# **VICTORIAN CIVIL AND ADMINISTRATIVE TRIBUNAL**

VCAT REFERENCE NO. P894/2022  
PERMIT APPLICATION NO. MPS/2020/799

<b>APPLICANT</b>	Harrison St Pty Ltd
<b>RESPONSIBLE AUTHORITY</b>	Merri-bek City Council
<b>REFERRAL AUTHORITY</b>	Melbourne Water
<b>RESPONDENTS</b>	Holy Protection Cathedral, Jane Ellison and others, Peter Mollison, Merri Creek Management Committee, Franco Paoletti
<b>SUBJECT LAND</b>	38 Harrison Street, Brunswick East
<b>HEARING TYPE</b>	Hearing
<b>DATE OF HEARING</b>	20, 21, 22 & 23 March 2023
<b>DATE OF ORDER</b>	13 April 2023
<b>CITATION</b>	Harrison St Pty Ltd v Merri-bek CC [2023] VCAT 398

Description of proposal	The construction of seven townhouses, one at two storeys in height with a roof deck, and the others at three storeys in height with roof decks, in addition to an existing single storey dwelling
Nature of proceeding	Application under section 77 of the <i>Planning and Environment Act 1987</i> – to review the refusal to grant a permit.
Planning scheme	Merri-bek Planning Scheme
Zone and overlays	Neighbourhood Residential Zone Environmental Significance Overlay 1 Heritage Overlay 90 Design and Development Overlay 1 Land Subject to Inundation Overlay De

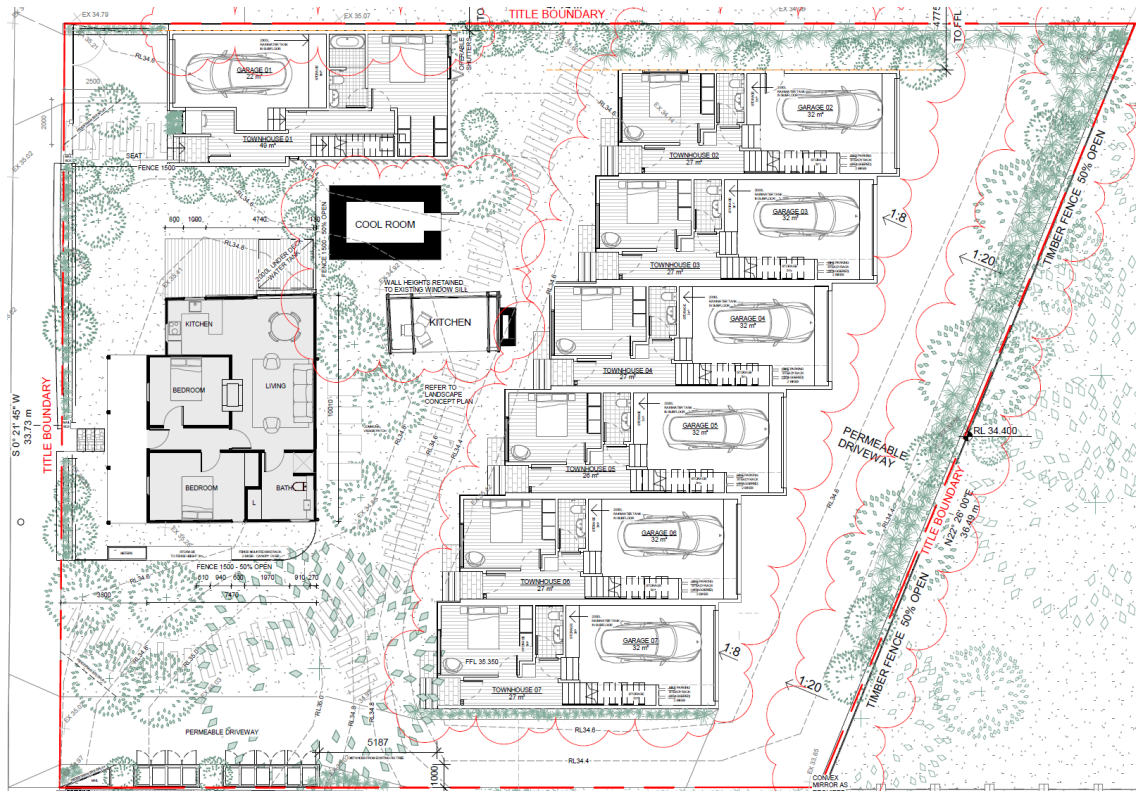
Street frontage and draw independent vehicular access directly from Harrison Street. To the rear of the review site are proposed a series of attached three storey townhouses (plus roof decks), that will sit adjacent to the Merri Creek corridor at the rear of the review site. A common driveway is proposed along the southern boundary of the review site, that then runs along the rear boundary providing vehicular access to garages in each of the three storey attached townhouses. This layout is depicted in the ground floor plan (A103) that is reproduced in part below.

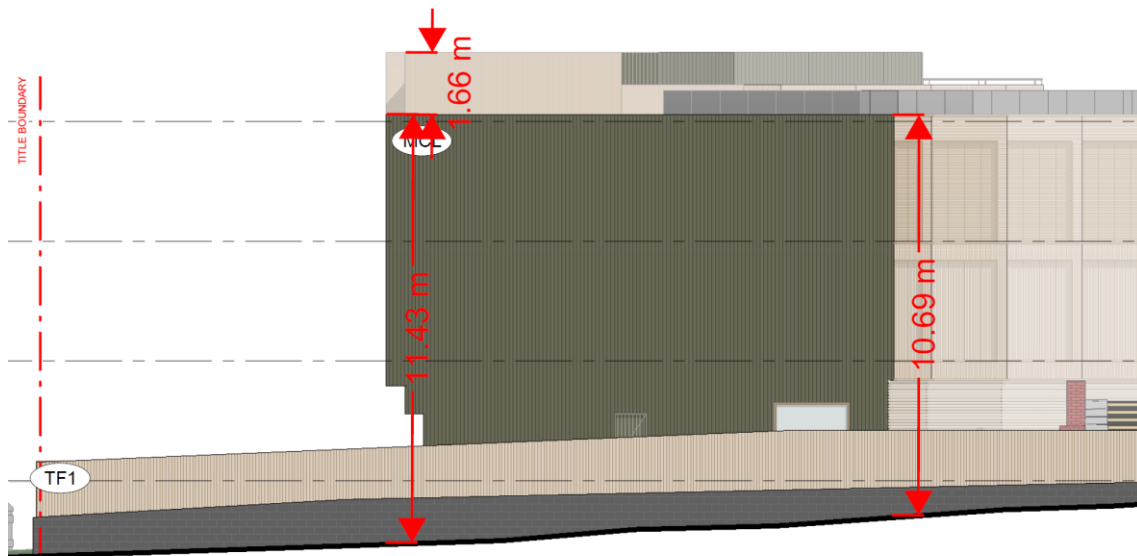
I say the apartments to the north of the review site are in a less sensitive location as, firstly, the review site is adjacent to a 'pinch point' or narrower portion of the Merri Creek corridor, and secondly as the Merri Creek Trail approaches the review site from the north-east in an alignment that directs views towards the review site in a manner which does not apply to the adjoining properties. The properties hosting these adjacent apartment buildings are also positioned more distant from the Merri Creek Trail that generally follows the alignment of the Merri Creek. As such, the review site is in a more visually prominent location in the context of the main pedestrian path through the Merri Creek corridor, as compared to the nearby apartment buildings. Given the policies that seek to limit the visual intrusion of development on public open space and public recreation trails, this context would ordinarily lend itself to a development of reduced built form scale on the review site, not an increase in scale as is proposed.

The context of the review site and adjoining properties to the Merri Creek corridor is depicted in the aerial photograph on the following page.

South elevation (with my dimensions added in red)

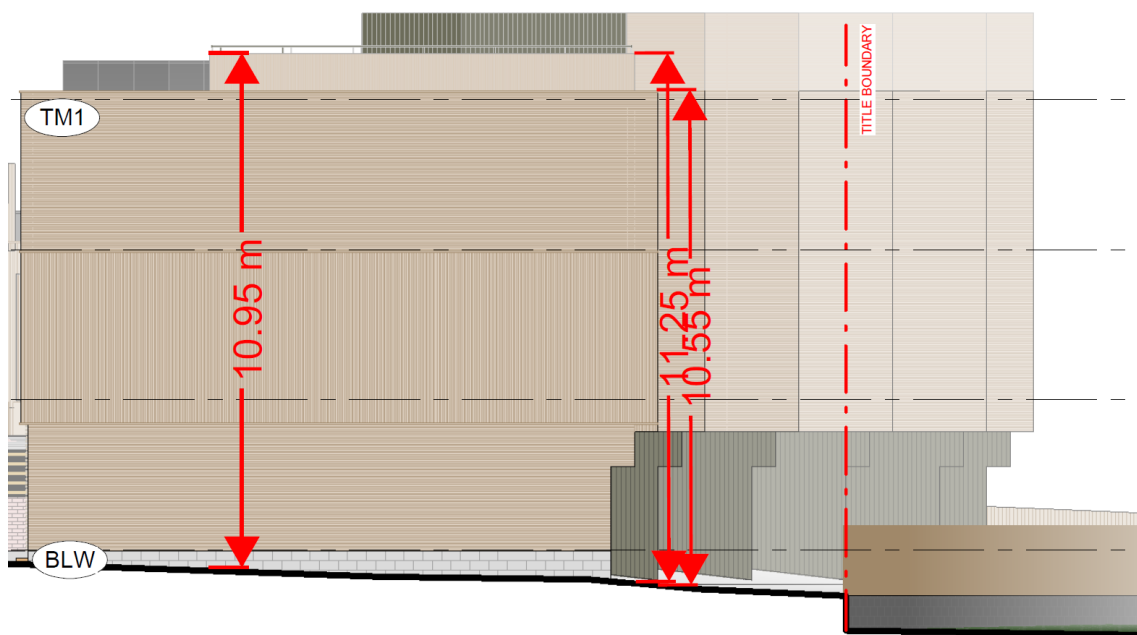
- b. The lack of articulation in the proposed built form. The east elevation of proposed townhouses 2 to 7 inclusive is articulated by a series of stepped setbacks from the angled rear boundary, however there is very little other articulation in the proposed built form. This results in a built form with a very poor level of articulation. I make this finding having regard to the manner in which the proposed first and second floors of each townhouse are in the same plane, and cantilevered towards the rear boundary as compared to the siting of the respective ground floors below. I also make this finding having regard to the repetitive arrangement of windows, framing elements, and roof decks to the eastern elevation of each of the proposed dwellings. This lack of articulation contrasts with the apartment building immediately to the north of the review site, where the building gradually peels back at each level in part, and is also eroded at each corner to further reduce the overall scale. Finally, the lack of any meaningful articulation in the proposed development for the review site is continued around to the expansive side boundary walls of the proposed attached three storey townhouses, which each comprise of a singular wall plane of a singular material and finish extending across the three levels, with the absence of any windows at the first and second floors. As a result, any view that is able to be gained to the side elevations of these attached three storey townhouses, would reveal a wall of some scale that is absent of any articulation, and which will therefore be a highly intrusive element into the surrounding landscape. These elevations are depicted on the following page.
